DP750/752/760/720/722/730 Firmware Release Notes

FIRMWARE VERSION 1.0.21.10

ADDED PIN FOR GDS TO OPEN 2ND DOOR

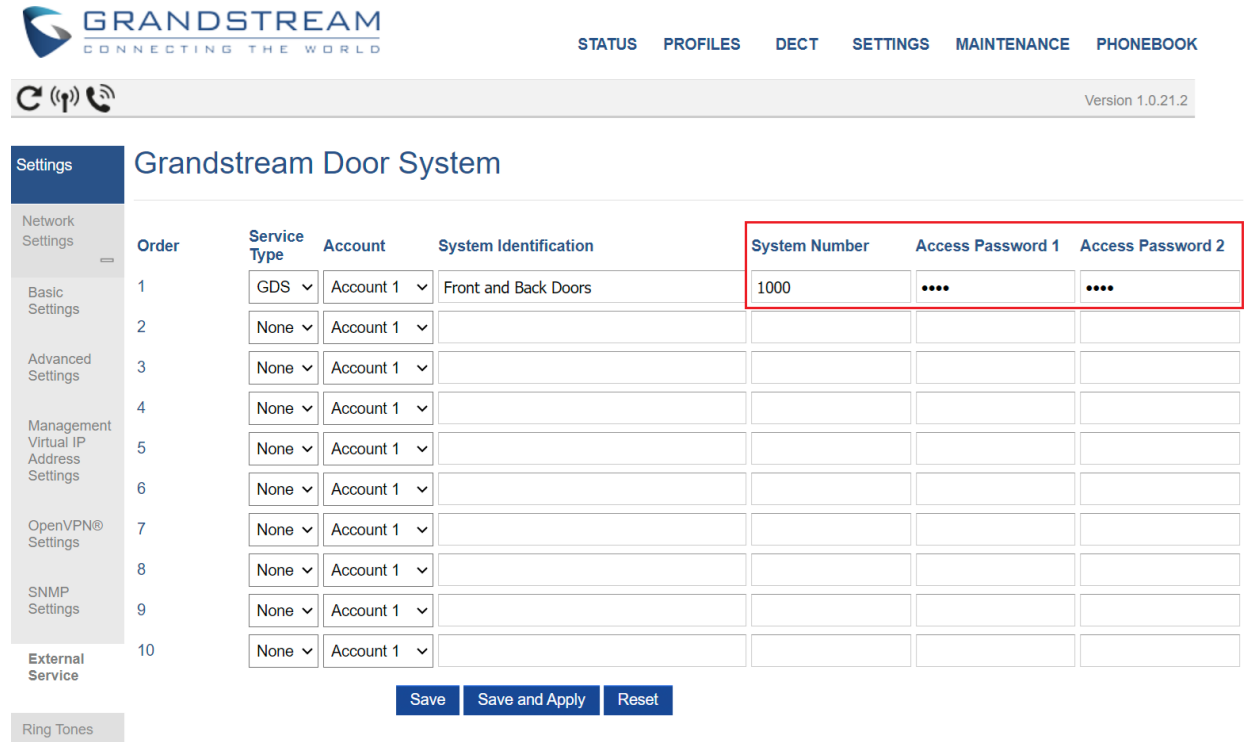
This settings allow user to configure password for open 2nd door if two doors are controlled by GDS37xx.

Once configured, when call established with the GDS37xx, user can operate the handset UI to select which door to open. The password needs to be pre-configured into the DP7xx via webUI.

Access Password 1 is for open door password of Door1; Access Password 2 is for Door2.

ADDED “ENABLE DND FEATURE”

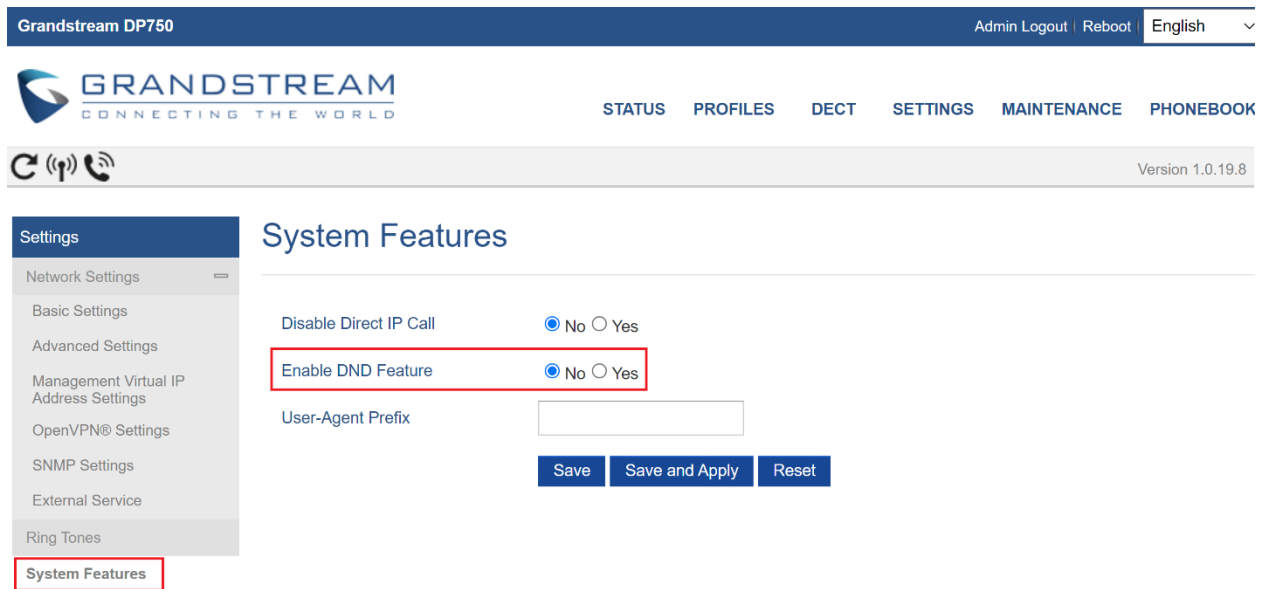
The default settings for “Enable DND Feature” is “Yes”, users can use DND feature in the Handsets.

When set to “No”, DND feature is disabled, users can NOT use DND feature in the Handsets. The Handset UI will show “Do Not Disturb” as “Disabled” when configure such settings in the Base Station UI.

This feature is requested by customers who do not want users accidentally activated “DND” and not able to get inbound phone calls.

ADDED ALLOW FAILBACK TIMER “0”

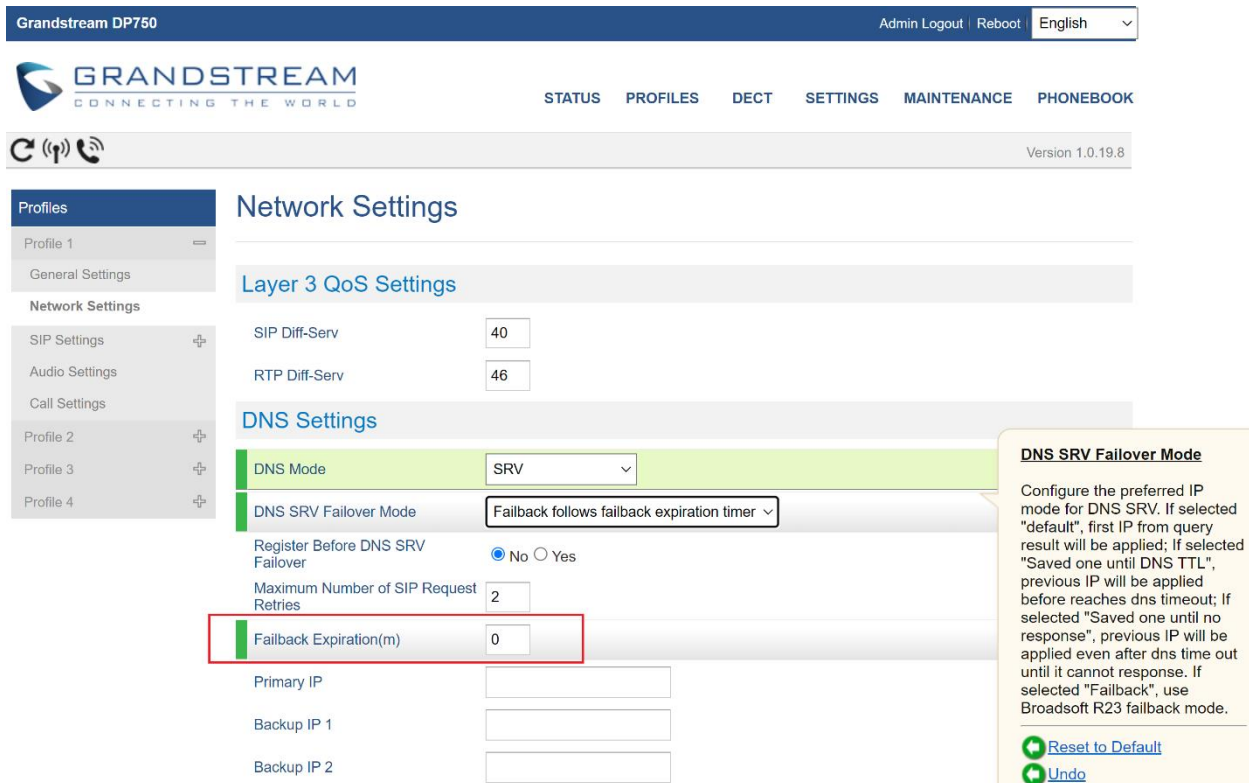
The default value for “Failback Expiration (m)” is 60 minutes. Added new value “0”, when configured, it disables the failback for Telstra Special Feature, which otherwise it is always checked regardless of IP mode.

NETWORK DIRECTORIES: CALL LOG

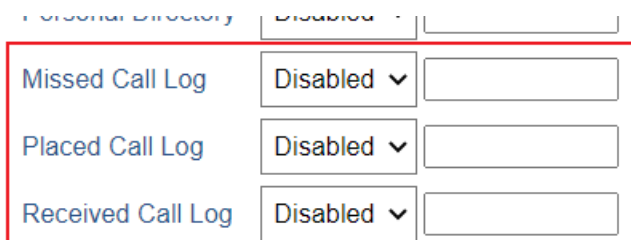
The device now supports configuring enable or disable “Missed Call Log”, “Placed Call Log” and “Received Call log” and the name of them. The setting can be found at Phonebook-> Global Phonebook Broadsoft XSI Settings-> Network Directories. By default, it is disabled.

OPERATION FOR 3-WAY CONFERENCE

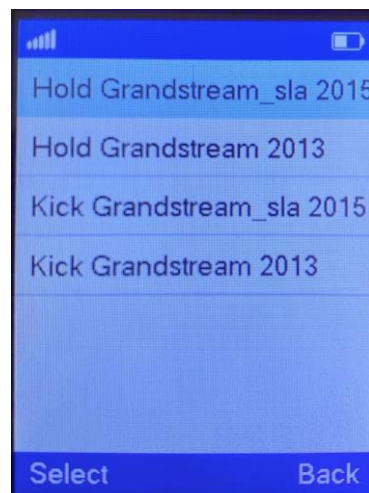
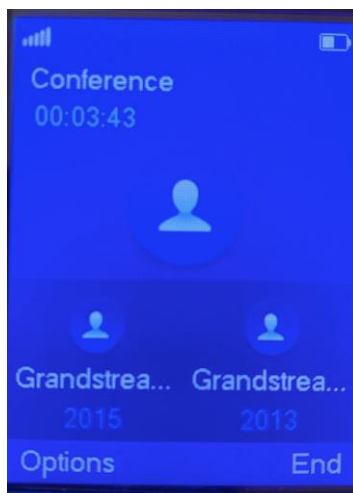
Since 1.0.17.3, if the handset bridged 2 calls into a conference, he now able to kick one of the participants without ending the whole conference, or he can also hold and unhold participants without kicking them off the call.
